## **AGENDA FOR REGULAR MEETING VILLAGE OF TINLEY PARK PLAN COMMISSION**

**ITEM #1      WORKSHOP – BRADY GILL FUNERAL HOME ADDITION, 16600 OAK  
PARK AVENUE – SPECIAL USE FOR A DWELLING ABOVE A PRINCIPAL  
USE AND SITE PLAN/ARCHITECTURAL APPROVAL**

# PLAN COMMISSION STAFF REPORT

The Petitioner, Melissa Christensen, of Brady Gill Funeral Home & Cremation Services, is proposing a two-story addition with related site changes to the existing Brady Gill Funeral Home at 16600 Oak Park Avenue in the B-3 General Business & Commercial Zoning District. The proposal requires Site Plan Approval and a Special Use Permit for a residential dwelling above the principal use.

*Proposed Addition's Ground Floor Plan (Garages for Apartment & Funeral Home, Mech. Rm., Storage)*

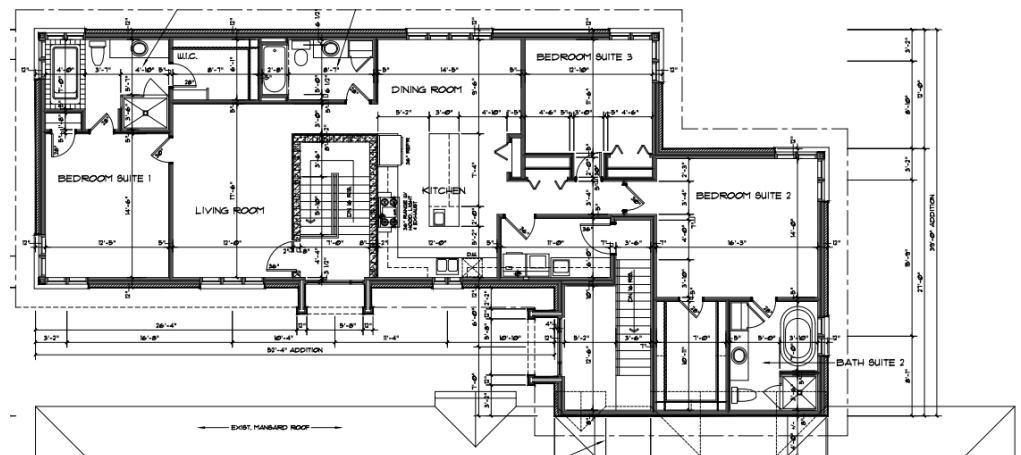
The proposed apartment will be the second floor of the proposed addition. The proposed orientation is to the northwest and rear of the existing funeral home, set back from Oak Park Avenue. Most of the addition will be obscured by the funeral home to Oak Park Avenue's frontage. The new driveway for the garage will be situated alongside the northwest side of the addition. There will be two entries for the apartment, both accessed via a courtyard. The primary entry will be entirely for the apartment's use, located along the courtyard's side with access to the two-car garage for the apartment, and stairs leading to the apartment. The mechanical room will be accessed through the the garage for the apartment. The secondary entry will be at the courtyard's end and have a foyer serving the funeral home and its garage for the funeral vehicles, with stairs leading to the apartment. That apartment entry has a door at the top of the stairs leading into its utility room. The storage room will be accessed through the garage for the funeral vehicles, and have a back exterior pedestrian door.

**Open Item #1: Discuss the request for a Special Use Permit for the addition of a residential unit above a principal commercial use.**

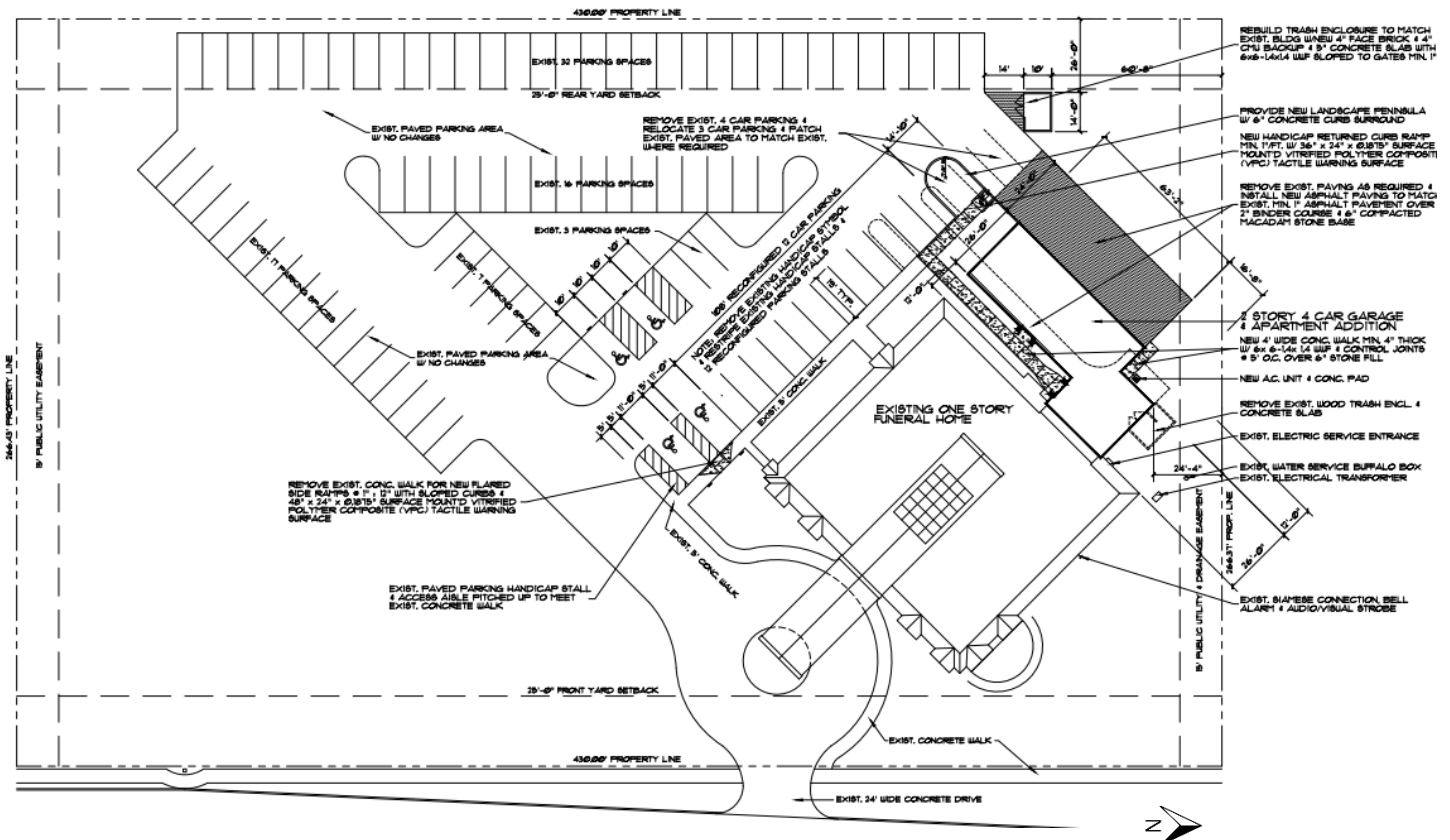
The addition will be northwest of the funeral home, partially connecting to it and providing a 12' wide courtyard. There will be a new concrete walk in the courtyard leading from the existing concrete walk along the east row of parking. A separate, short concrete walk will connect the storage room's exterior door to the end of the driveway access. The addition's driveway access will be shifted slightly from the existing driveway access location, so that it will be at the far northern end of the east parking row along the funeral home. The proposed driveway access causes some reconfiguration to that parking row. A landscaped, curbed parking peninsula (to meet the Village's Landscape Code) will be located between the driveway access and the parking row, which results in the loss of one parking space on that row.

The two existing handicap spaces with shared access aisle will also be restriped with 11' wide dimensions to meet Illinois Accessibility Code requirements. An accessible ramp is proposed on the concrete walk meeting the 5' wide shared access aisle. The new trash enclosure will be west of the driveway access, at north end of the parking lot's west drive aisle to allow for direct access by garbage trucks.

There will be a new ground mechanical unit located in the northern niche space between the back of the storage room and side of the garage. With the proposed site improvements, there will be some lawn remaining to the northwest corner of the side. The engineering plans depict a small corner of the driveway access cut so that it won't be in the public utility and drainage easement. The architectural site plan doesn't indicate this, but the Petitioner will be coordinating the plans for the public hearing.

**Open Item #2: Discuss the location and access for the proposed site improvements, including the two-story addition, driveway access, curbed landscape peninsula, and trash enclosure.**

Existing Conditions & Removal Plan

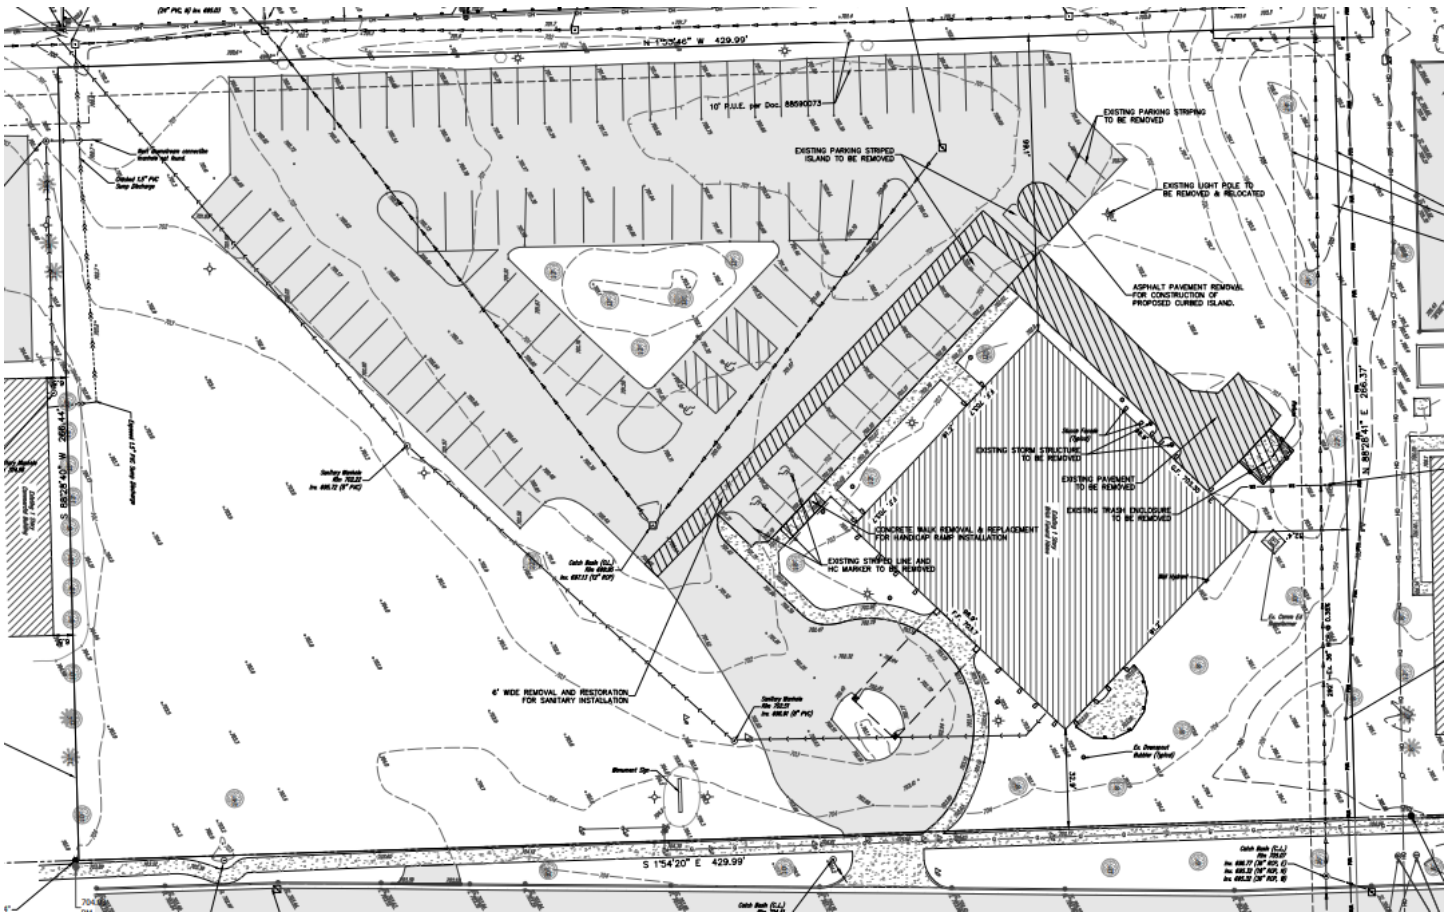
The engineering Existing Conditions & Removal plan shows the removal of the existing driveway access, asphalt for the construction of the proposed peninsula, and trash enclosure. The plan also shows a 6' wide removal and restoration for sanitary installation within the parking lot, and concrete walk removal and replacement for handicap ramp installation. According to the Site Development Data on the engineering Geometric Plan, the proposal has a +2,849 sq. ft. change in impervious surface. The Village Engineer has reviewed these submitted preliminary plans,

and the Site Plan/Architecture approval will be conditioned on final engineering approval of the drawings. The Petitioner has also submitted plans to MWRD, who has noted that a WMO permit will be required. Permit approval by the Village will require MWRD approval.

*Looking Southwest*

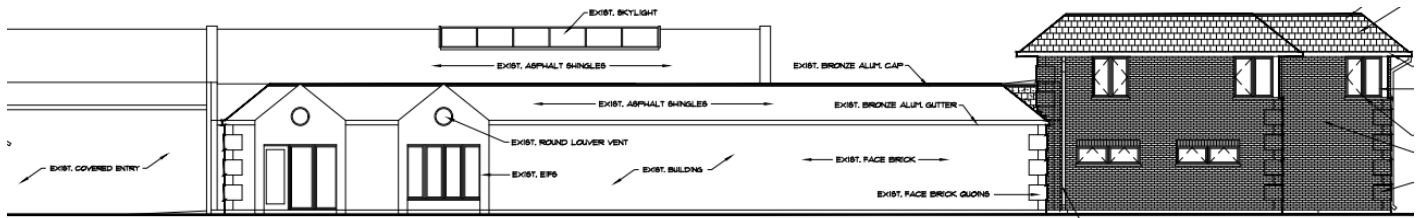
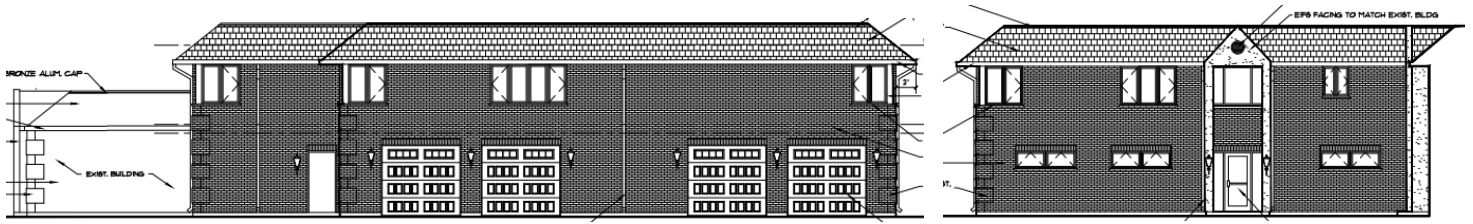
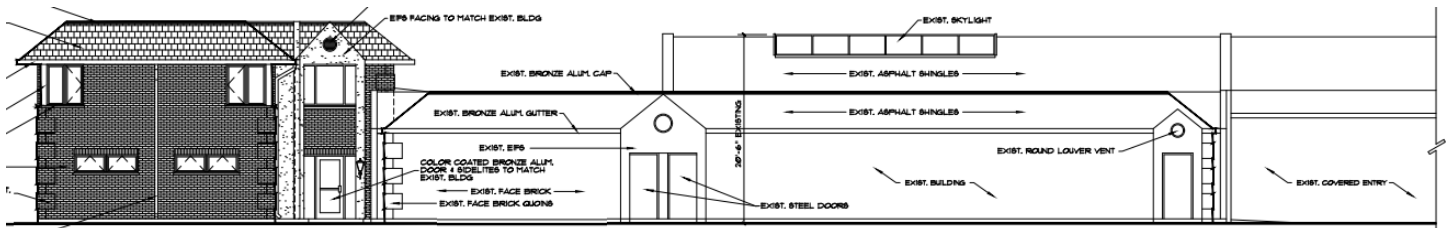
The addition's exterior materials and details will largely match the funeral home to help provide some visual continuity. The face brick and mortar, along with decorative quoin details at the corners, asphalt shingles with aluminum cap, and bronze aluminum gutters are all specified to match the funeral home. The downspouts will match the existing brick color. The Petitioner may not have physical material samples for the public hearing, but will be able to provide during the permit process for staff review and approval. The EIFS is a standard white color and the brick is a gray-beige tone.

The Petitioner originally proposed the entries to be entirely EIFS, but added the brick in the middle per Staff request. The Petitioner's architect believes that if the EIFS were continuous, it better matches the existing architectural EIFS treatments. However, Staff feels that if the EIFS were to be continuous without the brick or other break in material, it appears monolithic and out of scale. The existing EIFS entries adjacent to the addition are only one story. There are a couple other minor but notable new architectural elements. The new four steel garage doors will have a row of tinted windows and brick soldier coursing above. The second story corner windows will have corner wood columns (6"x6") wrapped in color coated bronze aluminum to match the existing building.

Lastly, the proposed "coachlight" lighting will differ from the more modern cylinder sconces elsewhere on the property. The Petitioner's architect proposes sconces and two light poles. He notes the sconces will mostly be on the northwest side of the building which does not visually conflict with the existing modern sconces. On the southwest façade (titled "Looking Northeast") there is one new entry sconce visible as well as two new light poles (not on the elevation drawing, but shown in the lighting plan) which will be pedestrian scale seven foot tall in front of the courtyard. There are no existing cylinder lights on the southwest façade so the proposed lighting does not appear have a visually conflict. The existing cylinder sconces are on the other facades of the funeral home. Staff also notes that this southwest façade is not a primary frontage of the building.

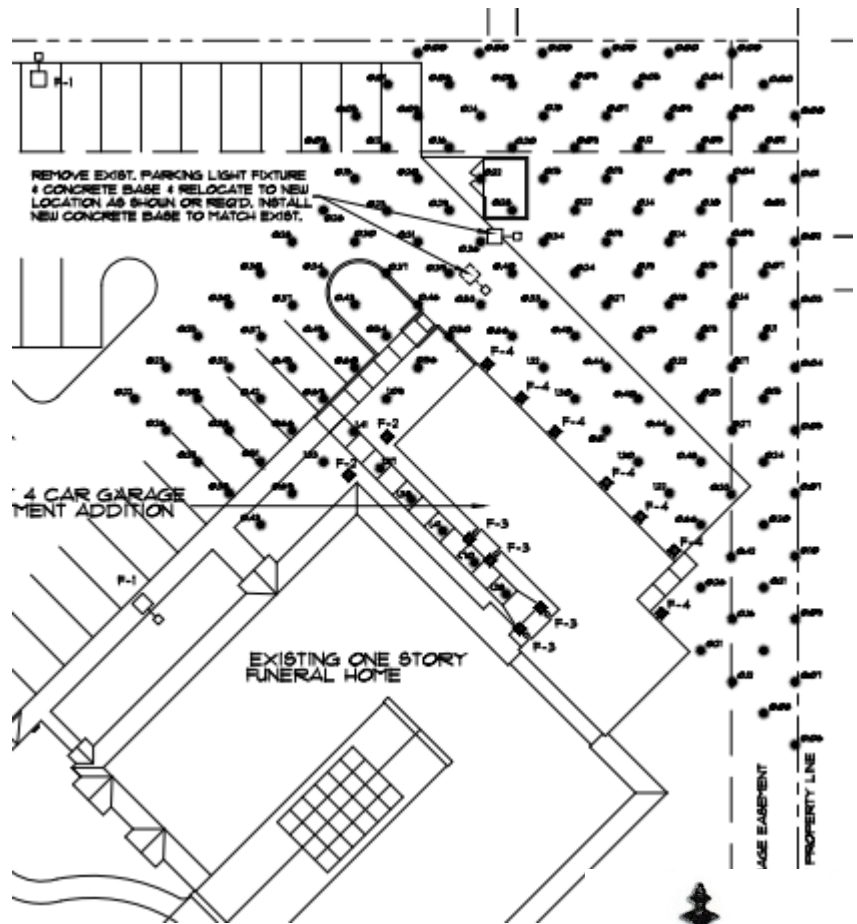
The Petitioner has provided a lighting plan showing photometric calculations for proposed lighting as it affects the area surrounding the proposed addition. Importantly, the Petitioner demonstrates that the maximum foot candles proposed is only 0.10 fc at the north property line and 0.00 fc, at the west property line.

The lighting proposal includes new wall sconces, two small light poles, and a slight relocation of an existing light pole out of the proposed driveway access to be east of the trash enclosure.

The architect’s plans indicate 0.10-foot candles at the property line abutting nonresidential (north) and zero foot candles abutting residential (west), which meets the Zoning Ordinance’s maximum requirements. The code regulates that property line foot candles adjacent to nonresidential properties be maximum 2.0-foot candles, and maximum 0.10 foot candles to residential.
